The City of Madera

Appendix B: Facilities

Access Compliance Survey Report

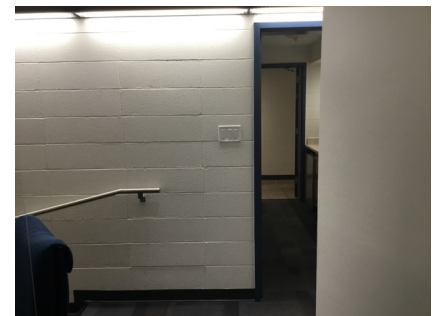
- 13
- *As-Built Description:*
Front approach: At push side, door does not have clear and level maneuvering space measuring door width x 48" (door width plus 12" if door has both, latch and closer).
 - *Proposed Solution:*
Provide relocated new door and frame; remodel walls as needed.
 - *Notes:*

Brochure Bins

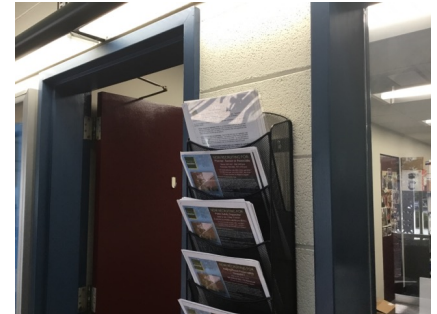
- 23 • *As-Built Description:*
Information brochure bins mounted above accessible height of 48".
- *As-Built:* **71.0" high**
- *Proposed Solution:*
Relocate/remount bins at accessible height.

Reach Range

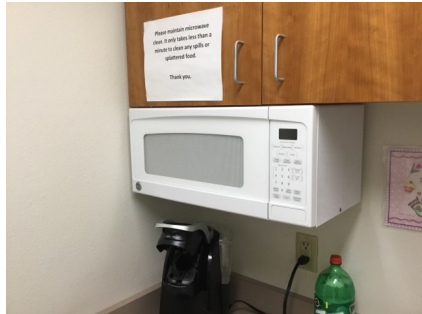
71	<ul style="list-style-type: none"> As-Built Description: Reach height to control or access point, where side approach is available, exceeds 48" or is less than 15" in height, or exceeds 10" in depth. As-Built: 59.0" high Proposed Solution: Modify equipment or mounting. 	PCODE IE02 ADAAG 91 4.2.6 ADA 2010 308.3.1 CBC 2007 1118B.6 CBC 2019 11B-308.3 Mitigated: <input type="radio"/> YES <input checked="" type="radio"/> NO	1	JOB	\$300	\$300

Cross Slope

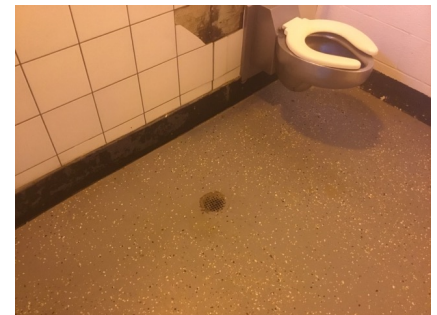
- 1731
- *As-Built Description:*
Cross slope more than 1":48" (2.083%).
 - *As-Built:* **2.6%**
 - *Proposed Solution:*
Modify cross slope. adjust drain as needed.

Water Closet

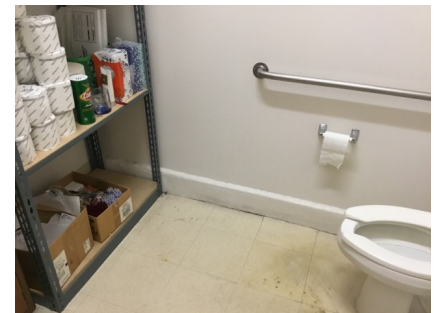
- 245
- *As-Built Description:*
CA only: In single-accommodation restroom less than 48" in front of water closet provided.
 - *As-Built:* **42.0" to metal shelf**
 - *Proposed Solution:*
Remodel restroom to provide at least 48" in front of water closet.
 - *Notes:*

Changes in Level

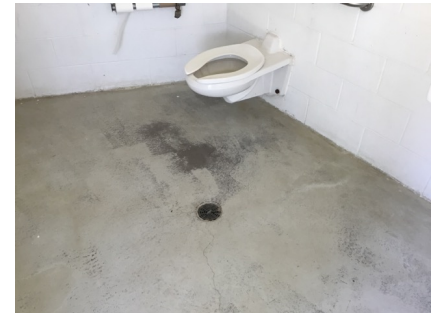
- 1891
- *As-Built Description:*
Walk: abrupt change in level exceeding 1/2" in accessible route.
 - *As-Built:* **0.5" level change at water closet.**
 - *Proposed Solution:*
Correct abrupt change in level and adjust drain as needed.

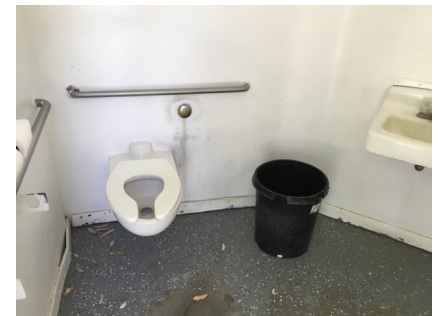
1949 • *As-Built Description:*
60" min. clearance around a water closet measured perpendicular from the side wall not provided (Fixtures are not allowed to overlap this clearance).

• *As-Built:* **57.5" to lavatory**

• *Proposed Solution:*
Relocate adjacent fixture and remodel restroom as needed.

Door

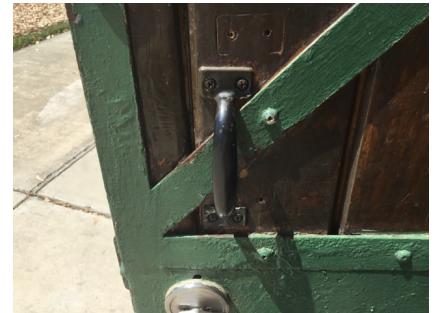
- 1952
- *As-Built Description:*
Door lock, latch or handle less than 34" or more than 48" above the floor (CA only: 34" to 44").
 - *As-Built:* **48.0" high**
 - *Proposed Solution:*
Relocate or replace existing hardware.
 - *Notes:*

Signage

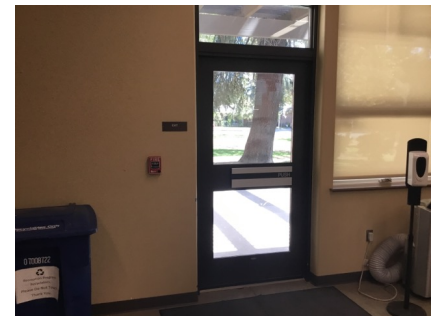
1003 • *As-Built Description:*
Sign not located on latch side of door and/or not located at 48" min. above to baseline of the lowest Braille cells and 60" max. to baseline of the highest line of raised characters.

• *As-Built:* **Wrong side**

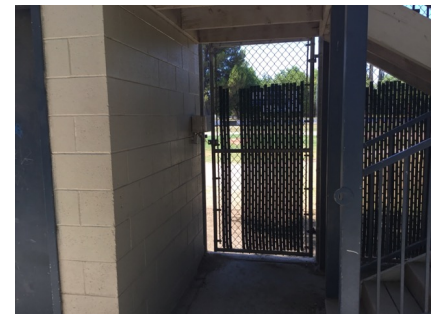
The shelves are also in the door maneuvering clearance.

- 1579
- *As-Built Description:*
Protruding objects more than 4" from wall, when bottom of object more than 27" or less than 80" above finished floor.
 - *As-Built:* **6.0" at 56.0" high**
 - *Proposed Solution:*
Remove/relocate protruding object. Patch existing surface.
 - *Notes:*

Cross Slope

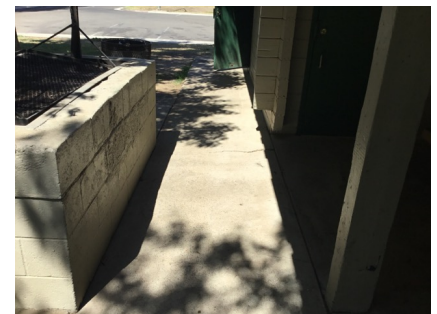
1556 • *As-Built Description:*
Cross slope more than 1":48" (2.083%).

• *As-Built:* **Up to 4.0%**

Door Threshold

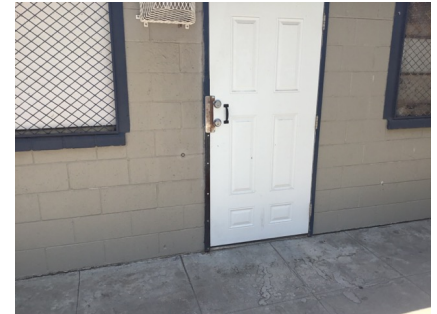
- 1389
- *As-Built Description:*
Door inaccessible due to threshold or step at door exceeding 1/2".
 - *As-Built:* **1.0"**
 - *Proposed Solution:*
Modify threshold to be no more than 1/2" by removing existing paving at door and providing landing with edge ramping (slope 1:20 max).

Signage

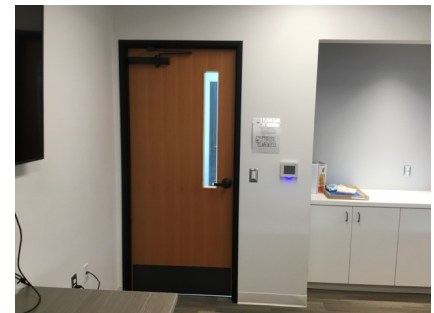
- 2121
- *As-Built Description:*
At door leading into exit corridor: Where required exit signs are installed, signs to provide exiting information for people with vision impairment are not provided.
 - *Proposed Solution:*
Provide raised letter/Braille "EXIT ROUTE" sign at door.

793

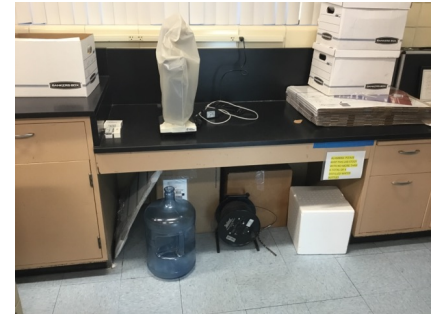
- *As-Built Description:*
Accessible fixed table or desk (top 28" to 34" high; knee space at least 27" high x 19" deep x 30" wide) not provided.
- *As-Built:* **24.0" knee clearance**
- *Proposed Solution:*
Remove skirt.

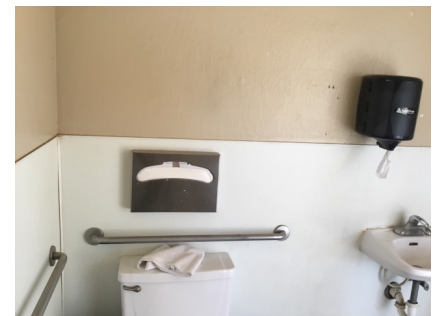
1224 • *As-Built Description:*
 60" min. clearance around a water closet measured perpendicular from the side wall not provided (Fixtures are not allowed to overlap this clearance).
 • *As-Built:* **54.0"**
 • *Proposed Solution:*
 Remove adjacent fixture and provide new enclosure at accessible water closet.
 • *Notes:*

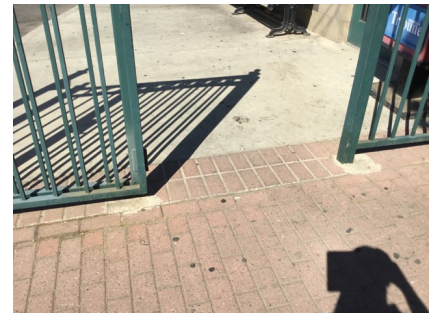
Occurs between the curb and alighting area.

- 446
- *As-Built Description:*
Walk: Pavement dislocation creates abrupt change in level exceeding 1/2" in accessible route.
 - *As-Built:* **1.0"**
 - *Proposed Solution:*
Remove, replace or repair area of pavement sufficient to correct abrupt change in level.

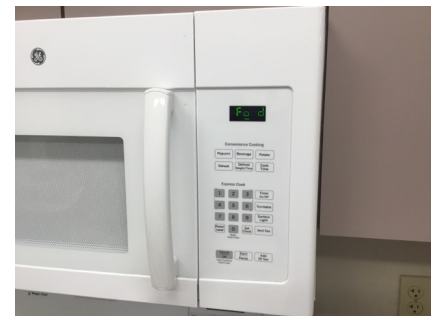
- 1296
- *As-Built Description:*
Reach height to control or access point, where side approach is available, exceeds 48" or is less than 15" in height, or exceeds 10" in depth.
 - *As-Built:* **59.0" high**
 - *Proposed Solution:*
Modify equipment or mounting.
